From: bschiffer <bschiffer@wwcengineering.com>
Sent: Tuesday, January 07, 2014 12:57 PM
To: Moore, Johari
Cc: 'Mike Griffin'; Saxton, John; StrataRossLA Resource
Subject: Re: Request for Additional Information to Develop Draft Programmatic Agreement
Attachments: ROSS_PA_Figure3_01.07.14.pdf

ROSS PROGRAMMATIC AGREEMENT
FIGURE 3

PHASE I
DIRECT IMPACT AREA

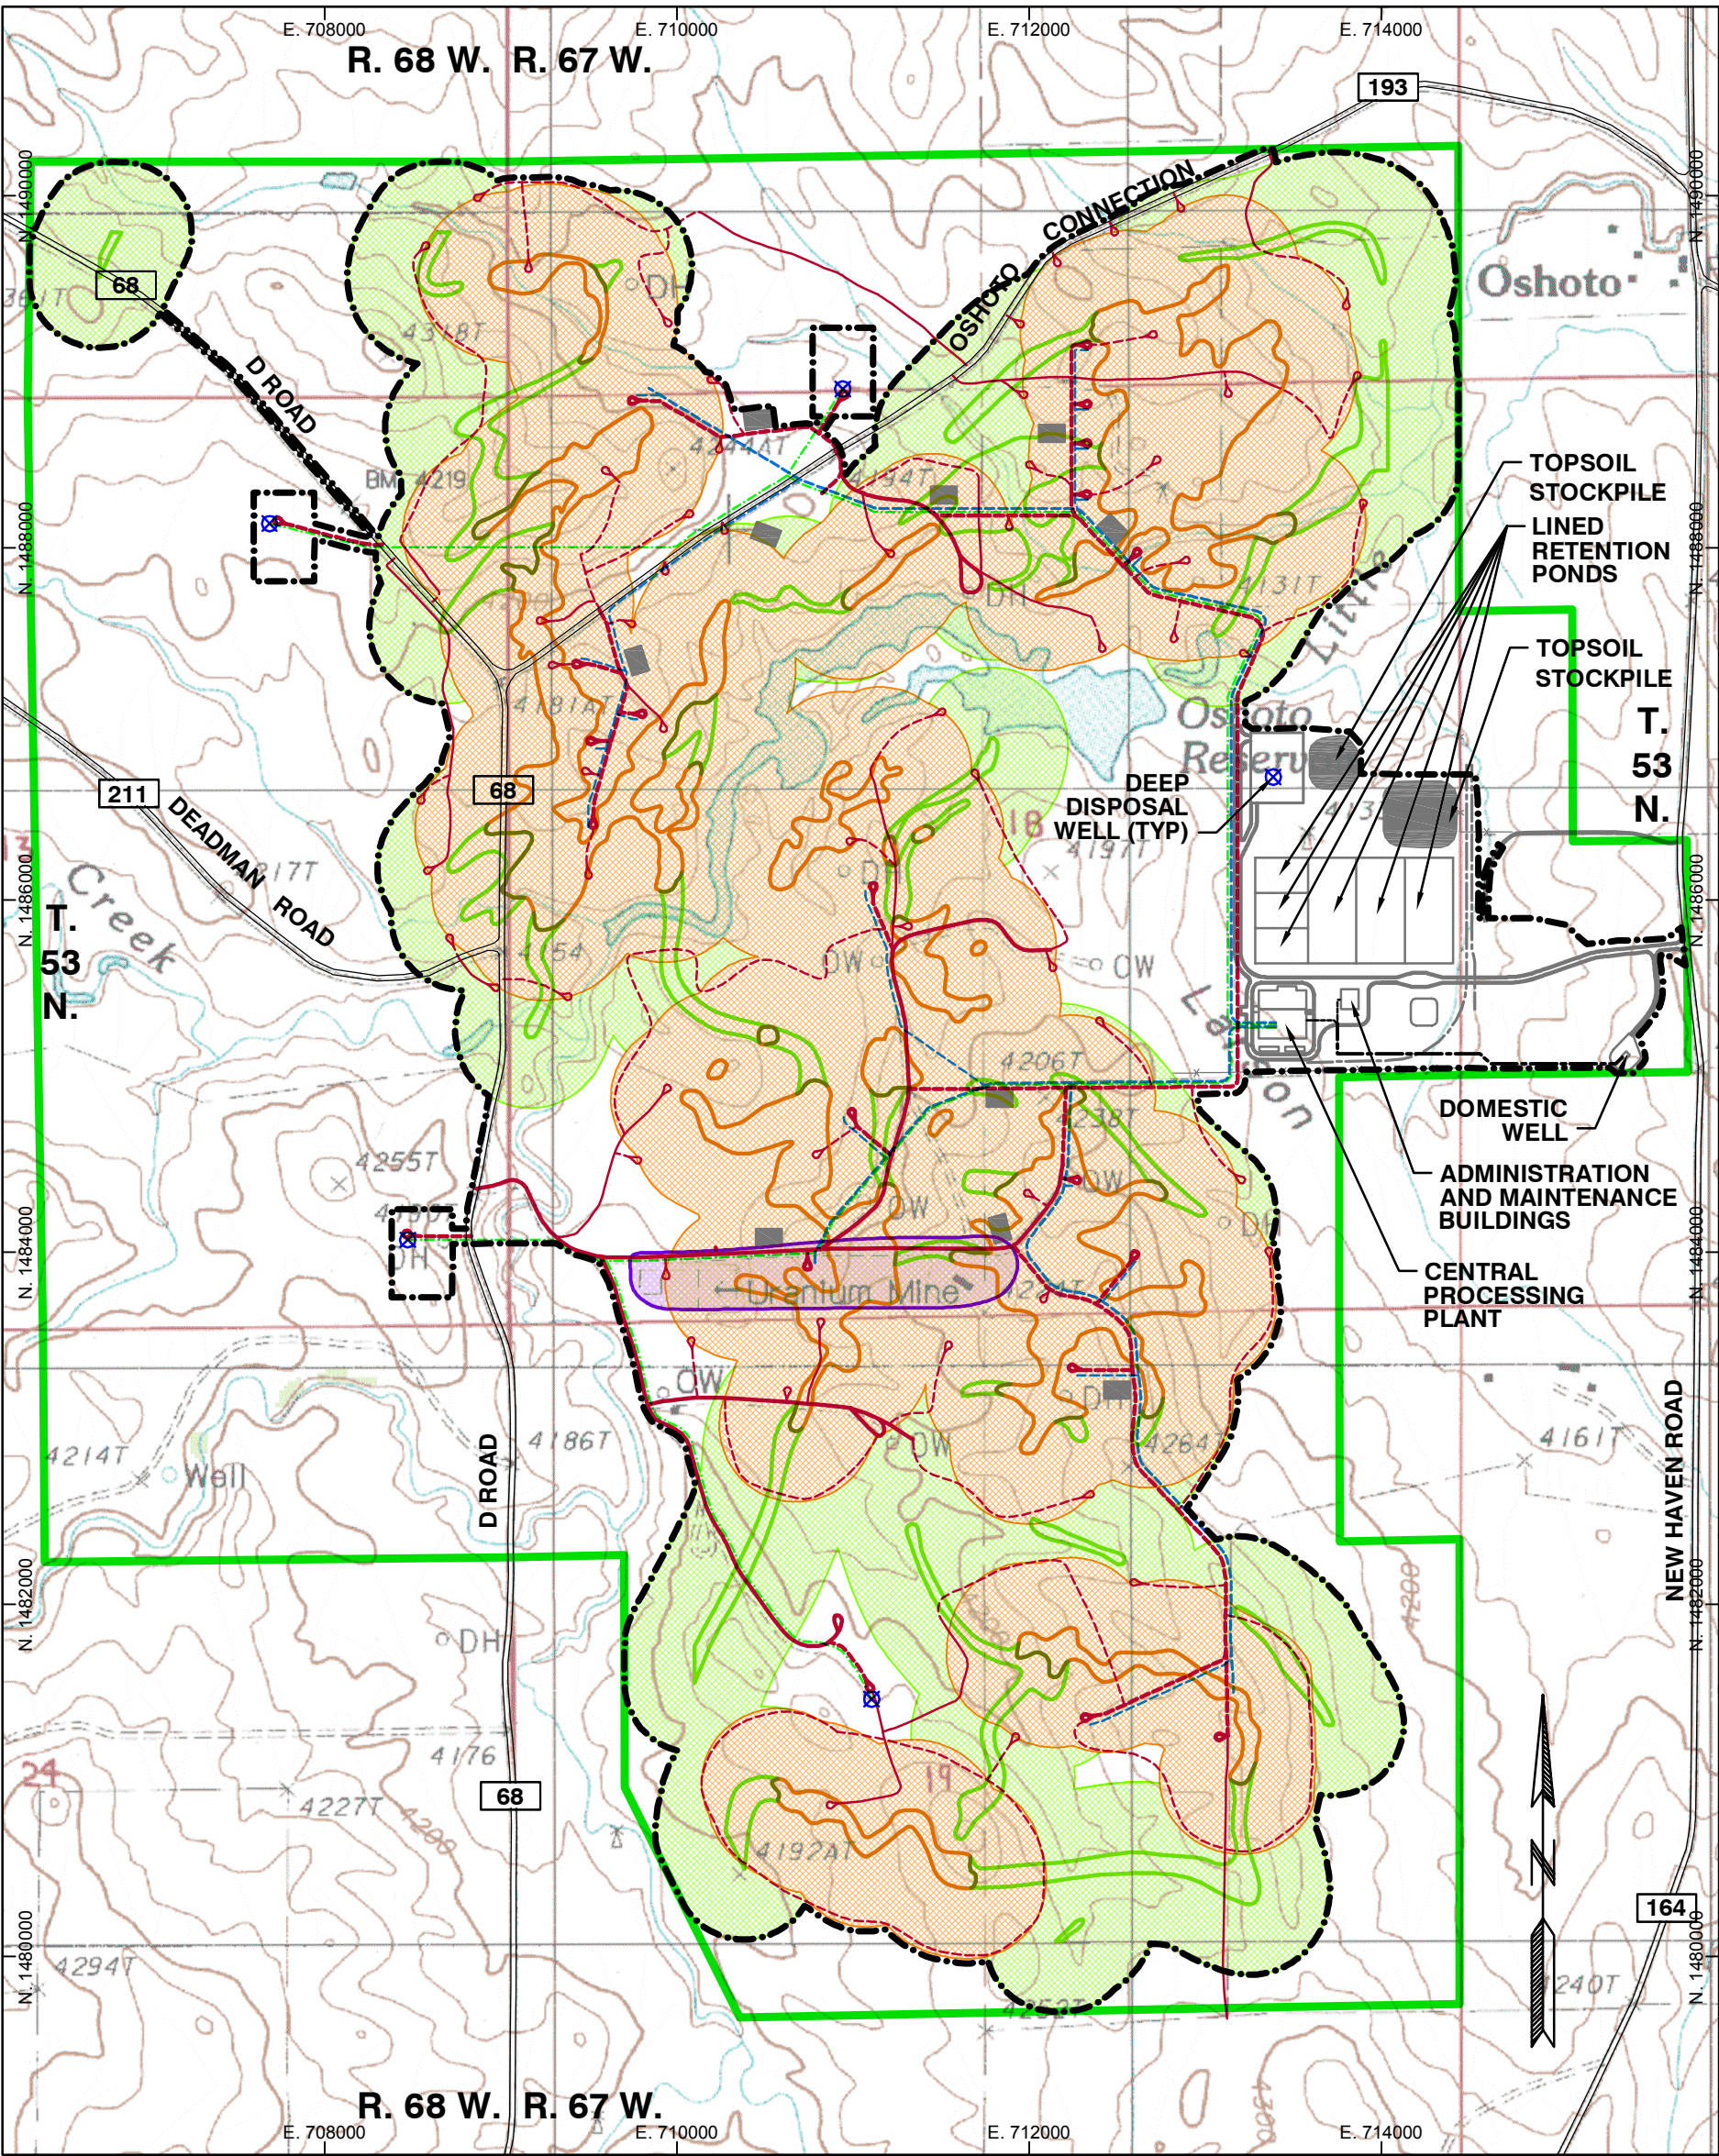
1 – Revised Figure 3 of Appendix A to the PA.

Currently, Figure 3 of Appendix A to the PA is Environmental Report Figure 1.2-6. Please provide a new figure labeled Figure 3 that shows a boundary around the area(s) currently expected to be disturbed by the Ross Project (i.e. Phase 1). This figure should also show the Project structures and activities (e.g. CPP, roads, pipelines, wells, wellfield areas) currently proposed to be located within the Phase 1 area(s).

Please see the attached pdf providing a revised Figure 3 for Appendix A of the Ross PA. Let Mike or I know if you have any questions.
